Alexander Stadium Redevelopment

Design updates
April 2021

Design updates

A masterplan extract showing the location of the two additional pathways

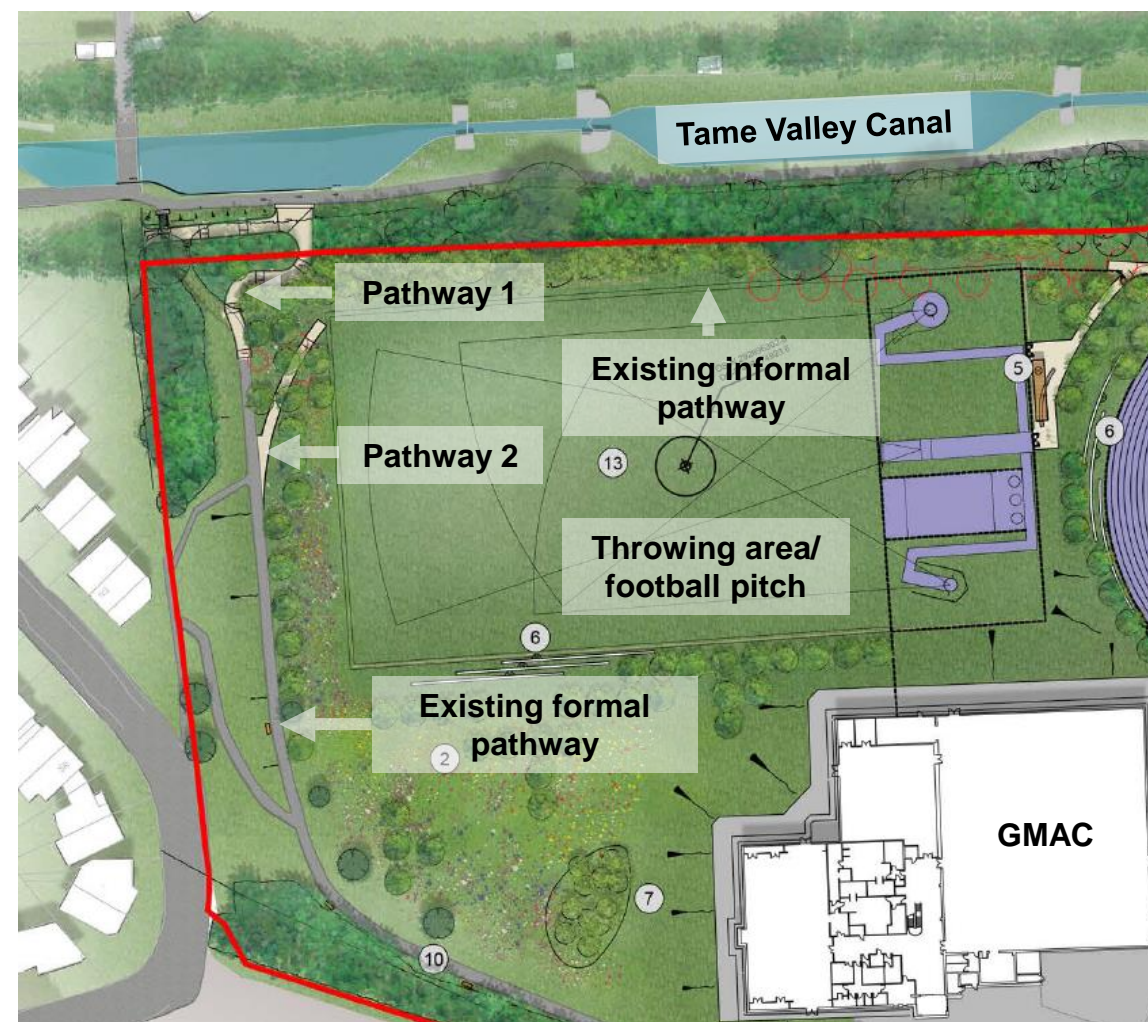
In 2020, the Canal & River Trust (CRT) installed a gently sloping pathway between the north-west corner of the Alexander Stadium site and the Tame Valley Canal towpath. This pathway is marked as '**Pathway 1**' on the masterplan on the right. The pathway provides a valuable additional access route between the canal and the stadium site.

Whilst **Pathway 1** was installed by the CRT, it falls partly within the Alexander Stadium site (on land owned by Birmingham City Council) and therefore we would like to seek formal approval of the pathway from the Council's planning department.

This pathway is marked as '**Pathway 2**' on the masterplan on the right, and would be installed by the Alexander Stadium Redevelopment team. **Pathway 2** would not impact any existing trees or vegetation. It would require minor changes to the arrangement of proposed trees in the vicinity, but the quantity of proposed trees would not change. The latest tree planting arrangement is shown on the planting plan on the next slide.

A pre-Commonwealth Games planting plan extract showing the updated tree planting arrangement in proximity to Pathway 2

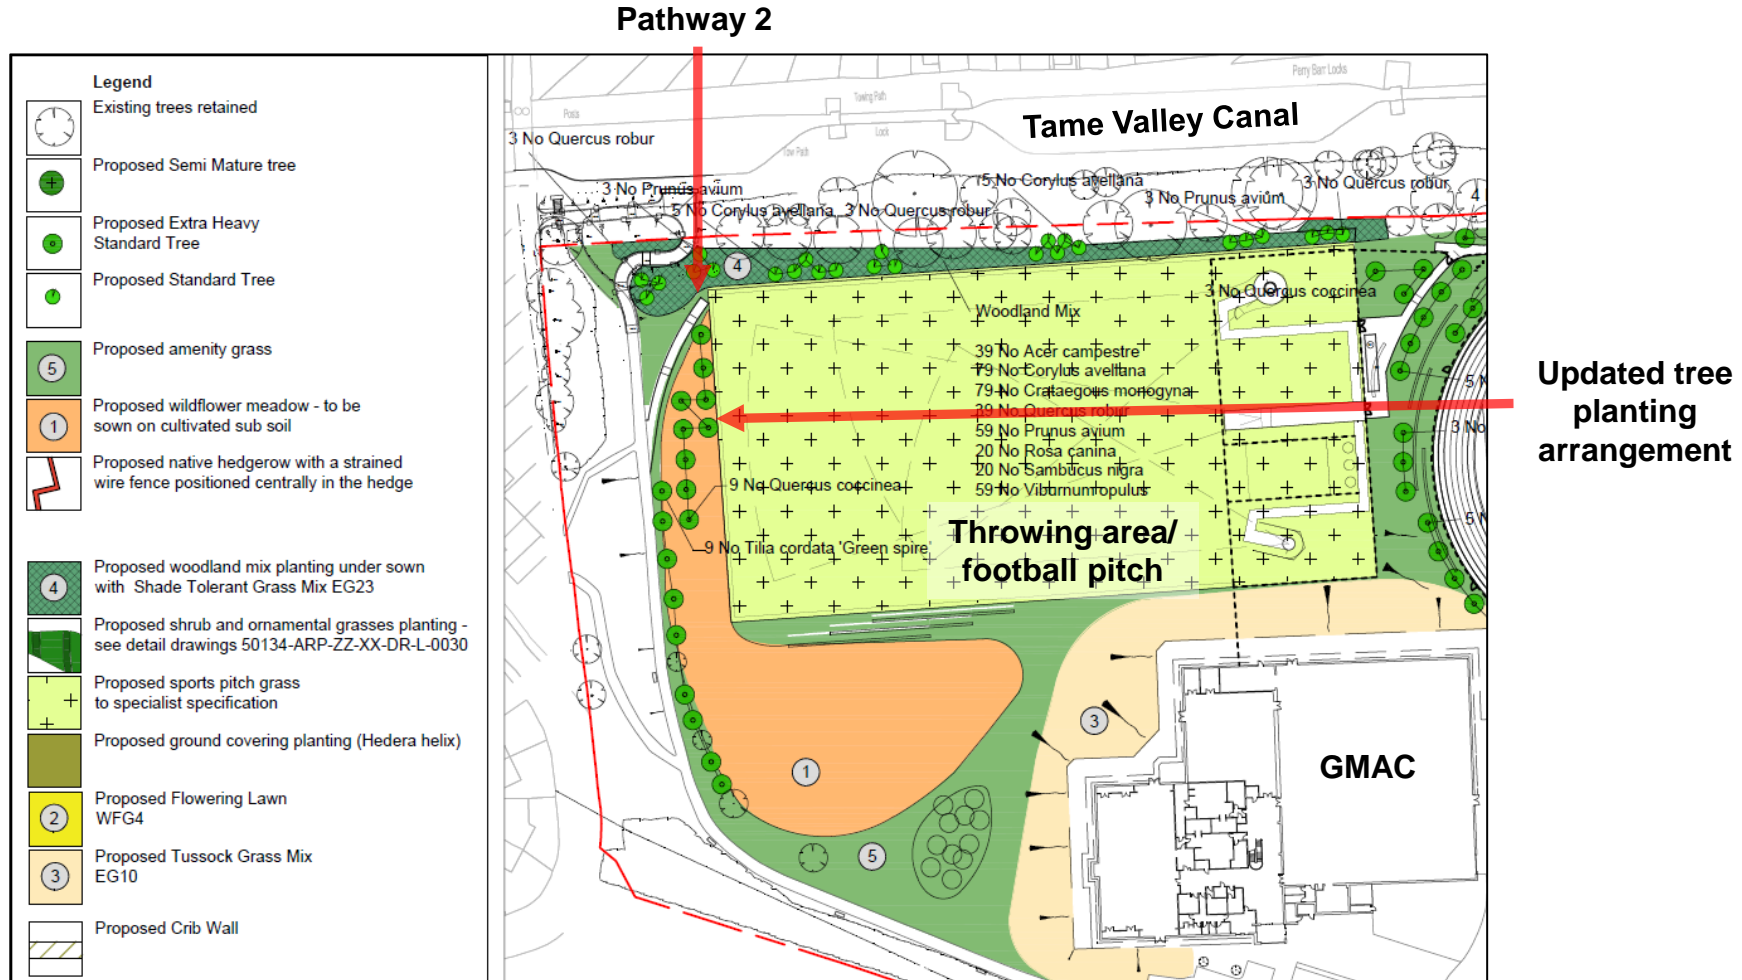
The latest tree planting arrangement in proximity to **Pathway 2** is shown on the pre-Commonwealth Games planting plan extract below.

A masterplan extract showing the original East Stand South Retaining Wall, and existing bridge

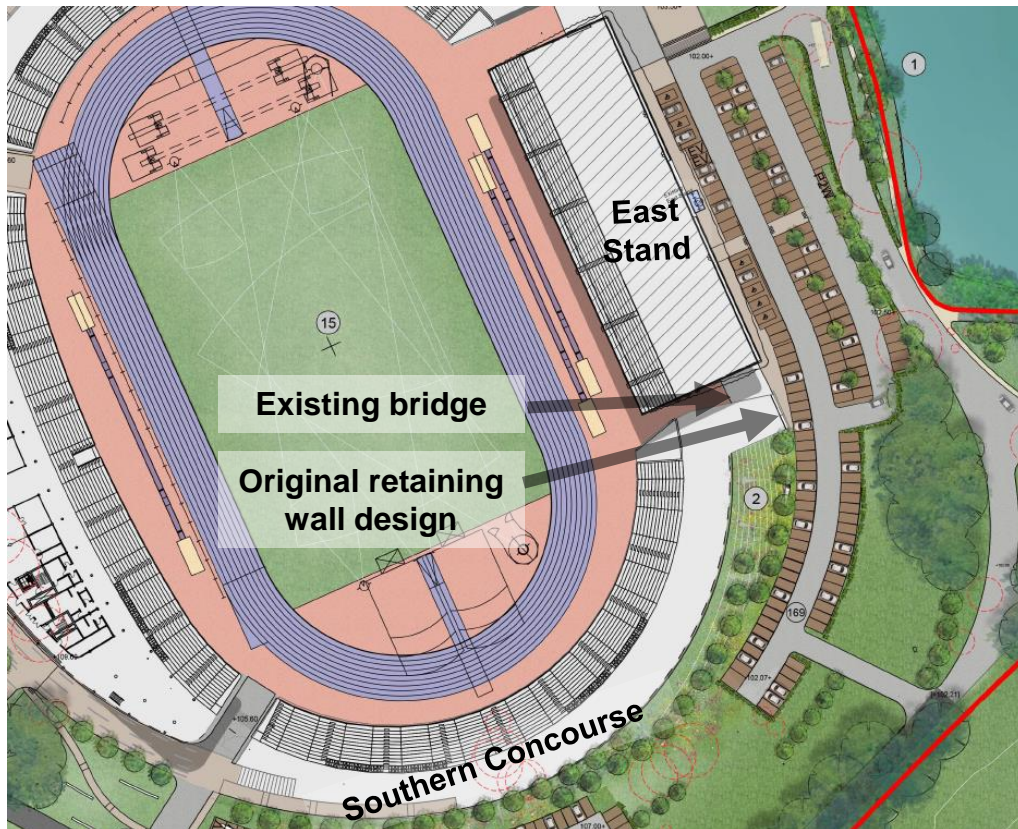
In the original Alexander Stadium Redevelopment design, use of an existing bridge was intended to provide a connection between the East Stand and the Southern Concourse. The location of the bridge is shown on the images below.

The 'East Stand South Retaining Wall' is a structure which would support the bridge, and retain the ground allowing a connection to be made between the bridge and the Southern Concourse. The location and original design of the retaining wall is shown on the images below. The original design of the retaining structure involved a blank vertical wall.

A drawing showing the relocated car parking spaces

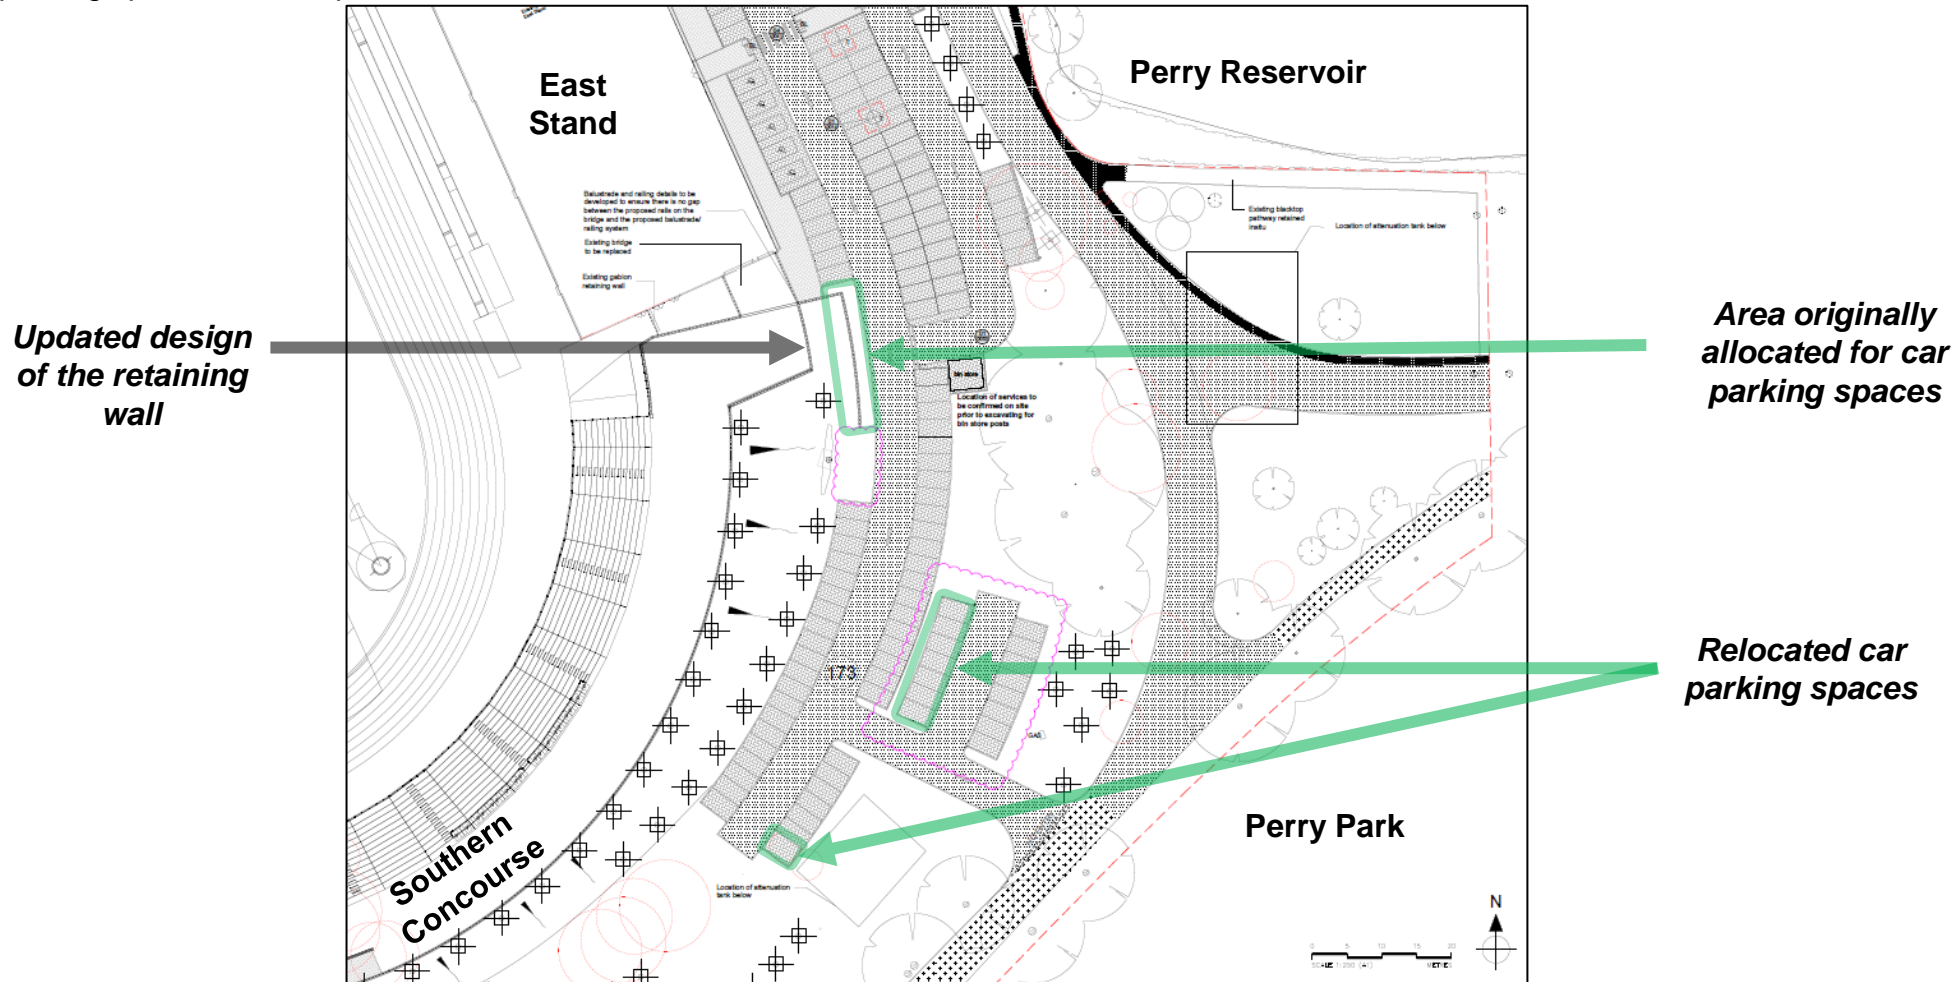
The updated design of the East Stand South Retaining Wall requires the wall to step out into an area originally designated for car parking spaces. Eight car parking spaces would be affected and therefore would be relocated. The original, and new locations of the car parking spaces are outlined in green on the drawing below. This change would not impact any existing trees or other vegetation. However, an additional tree and a hedgerow will be planted between the relocated parking spaces and Perry Park, to help integrate the parking spaces into the parkland.

Drawings showing the location of the lighting columns and steel frames, areas originally allocated for car parking spaces and the relocated car parking spaces

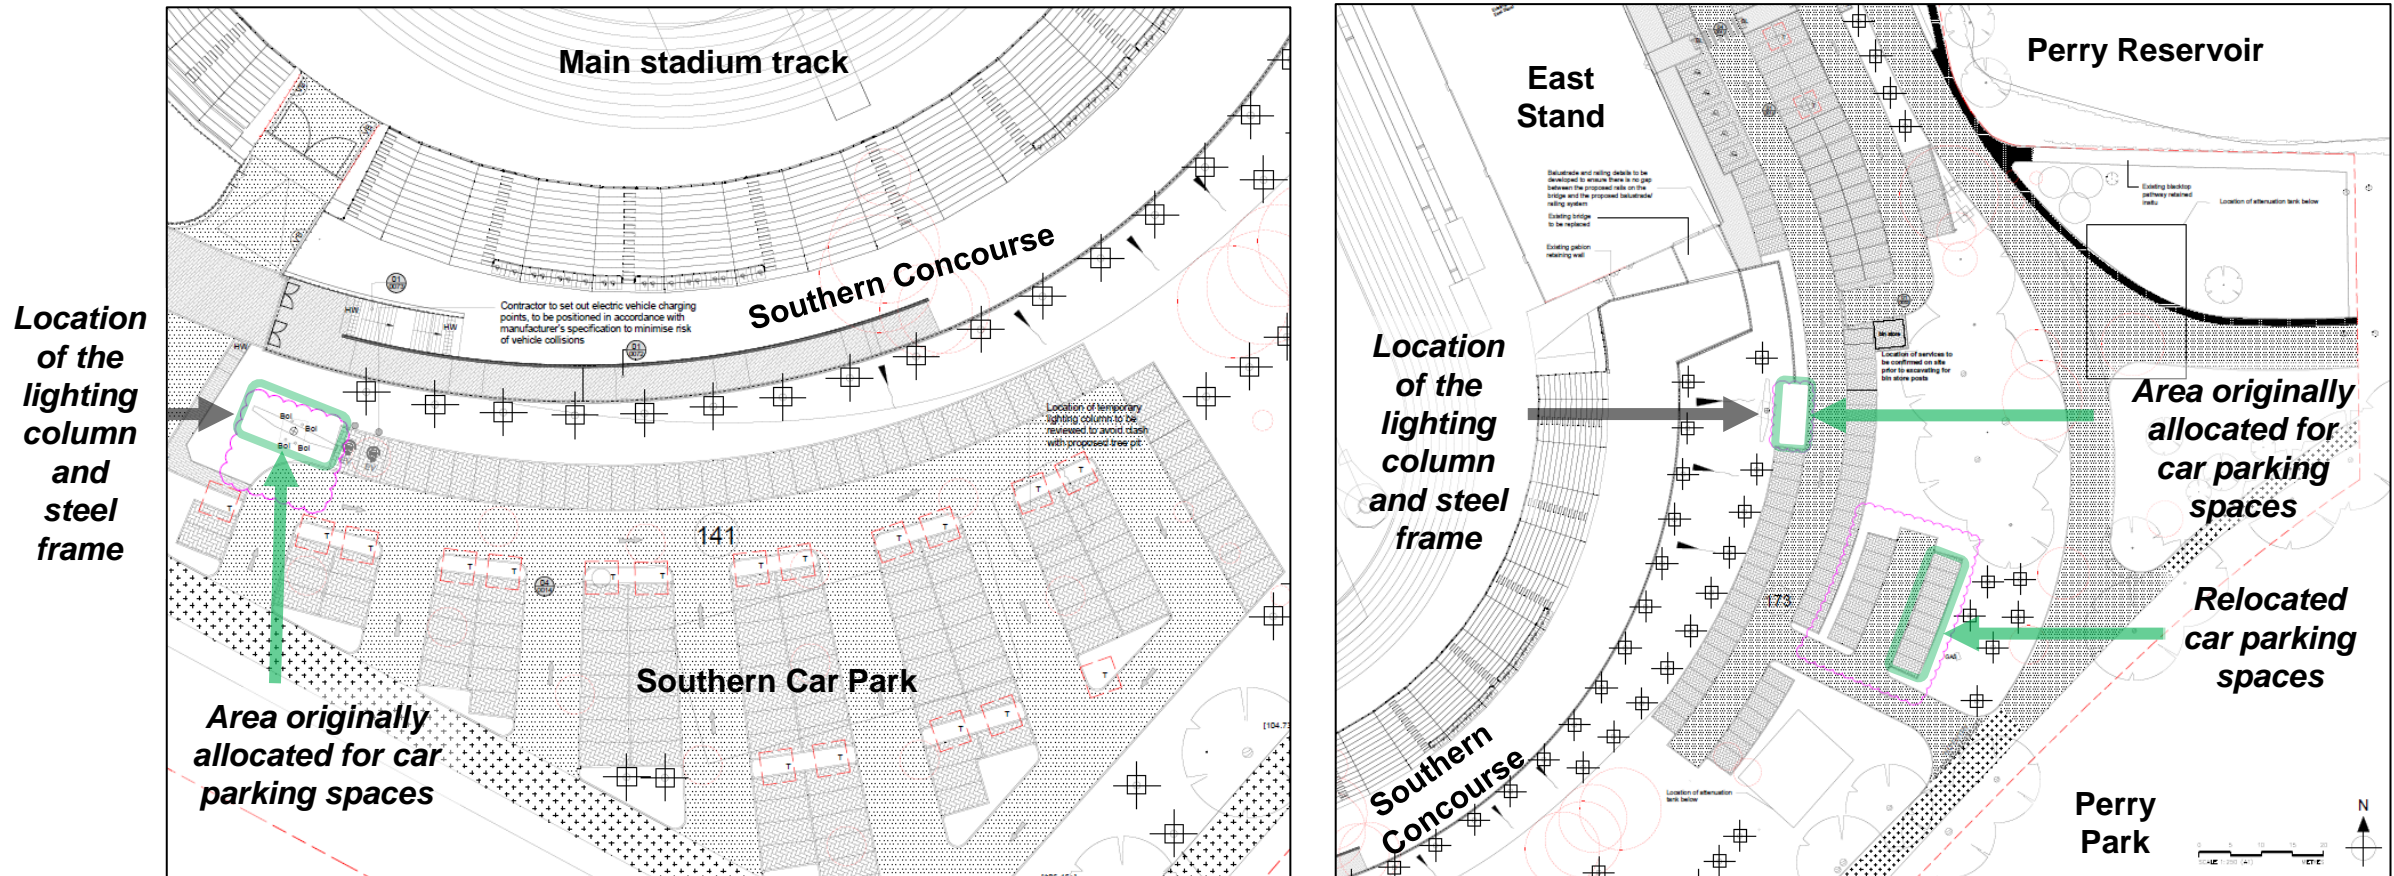
The Birmingham 2022 Organising Committee recently submitted an application to Birmingham City Council seeking approval for temporary changes to the four lighting columns which will be located in each corner of the stadium (application reference number: 2021/02809/PA). The proposal includes installation of a temporary steel frame around each lighting column to support a 'catenary cable' which will be installed at Games time to hold lighting and speakers for broadcasting. Two of the steel frames would fall into areas originally designated for car parking spaces. Eight car parking spaces would be affected and therefore would be relocated. The original, and new location of the car parking spaces is outlined in green on the drawings below. The relocation of car parking spaces would not impact any existing trees or other vegetation. However, as described on the previous slide, an additional tree and a hedgerow will be planted between the relocated parking spaces and Perry Park, to help integrate the parking spaces into the parkland.

A drawing showing the location of the car parking space that would be removed from the design of the Southern Car Park

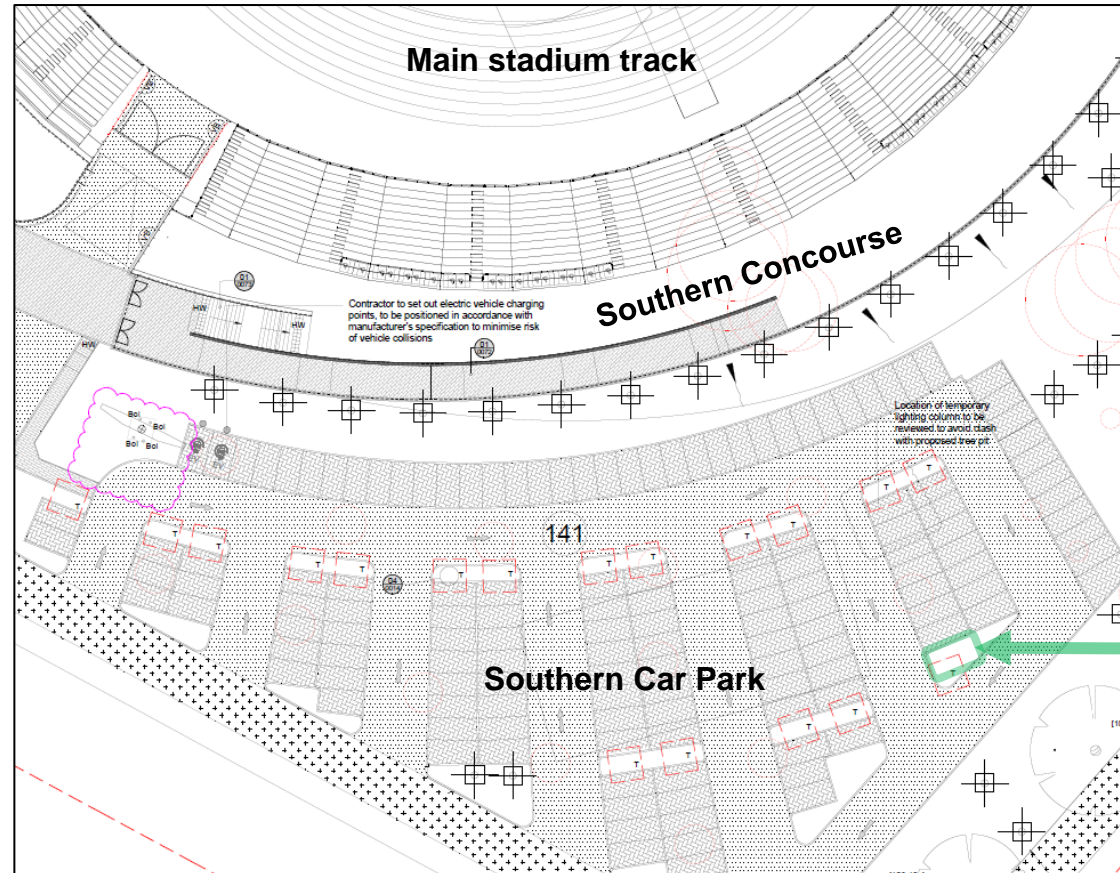
It is proposed that one less car parking space is provided in the Southern Car Park given the space constraints, and to ensure there is sufficient space to accommodate the proposed planting, both before and after the Commonwealth Games. The location of the car parking space that would be removed from the design of the Southern Car Park is outlined in green below.
